Generic Design Assessment of the BWRX-300 – Step 2 Assessment of Radiological Protection

Project Name: Generic Design Assessment of the BWRX-300 – Step 2

Report Title: Step 2 Assessment of Radiological Protection

Assessment report reference: AR-01352

Figure 1: Comparison of BWRX-300 Results to ISOE Industry Operating Data (ref. [6])

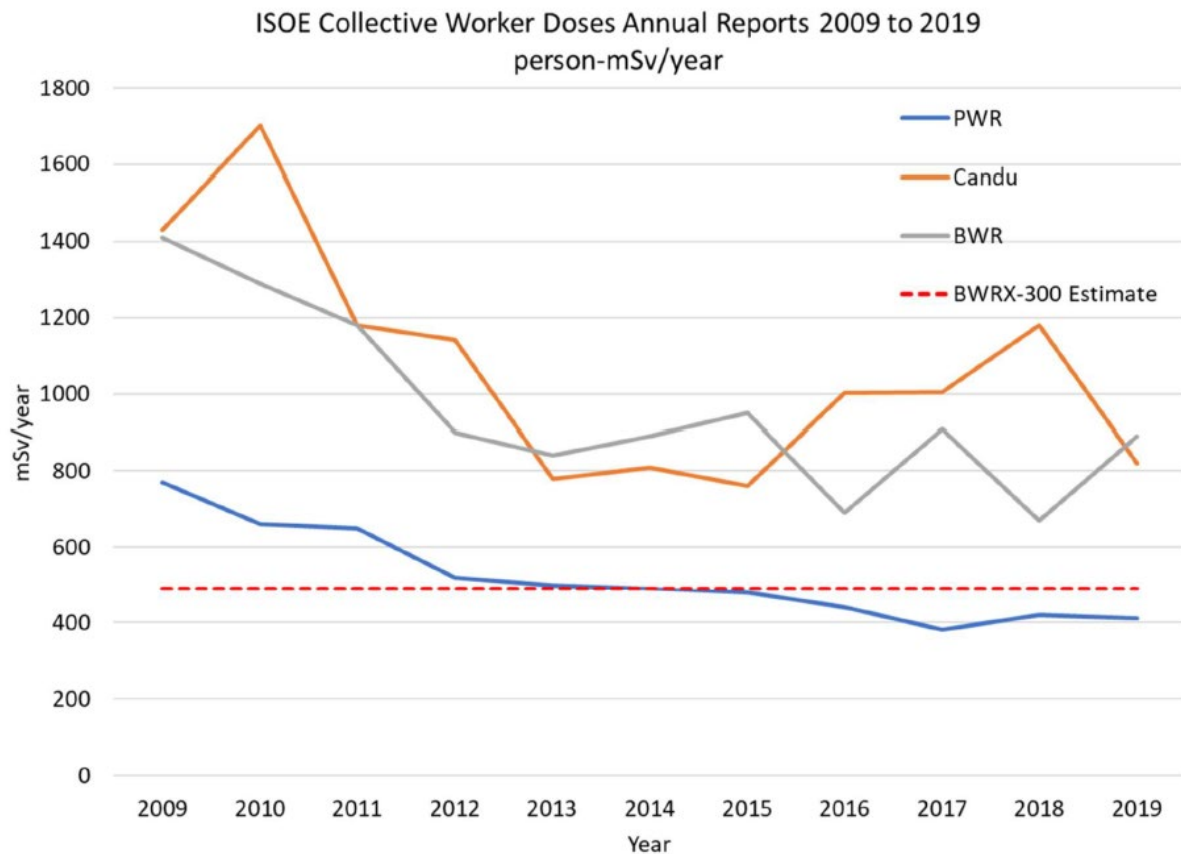
129. Whilst there are no regulatory limits for collective dose, it can be a useful performance metric for comparison with other operating NPPs. The annual collective dose to workers is estimated to be 491 person-mSv/y for the BWRX-300. PSR Chapter 12 compares the BWRX-300 annual collective dose with other operating BWRs taken from ISOE (Figure 1).

130. The comparison indicates that the BWRX-300 doses will be significantly lower than the average annual collective dose for all operating BWRs in ISOE database of ~800 person-mSv/y (2015-2019). However, I would consider it more suitable to benchmark the BWRX-300 against similar, modern, or better/best performing BWRs. For example, the annual collective dose for the BWRX-300 is similar to that of the more modern and much larger UK ABWR (ref. [79]) with annual collective dose of 500 person-mSv/y. I would expect the doses for the BWRX-300 to be significantly lower than the UK ABWR, due to being significantly smaller and having fewer systems to operate and maintain as described in PSR Chapter 12. However, I do recognise that at Step 2, the annual collective dose estimate for the BWRX-300 is preliminary, conservative, and subject to further refinement and optimisation during detailed design, which may reduce annual collective doses to workers.

131. The collective dose estimates in conjunction with minimum staffing levels (to be established by the HFE team) will provide an average estimate of the individual doses to all workers; however, further work will be required to demonstrate compliance with IRR17 dose limits and ONR SAPs targets. For example, a future submission will need to provide a sufficiently detailed worker dose assessment to demonstrate that the average doses to defined groups of workers is below the BSL for Target 2 (Table 3); I would expect this to be addressed in the FAP as part of PSR12-2 (ref. [6]).
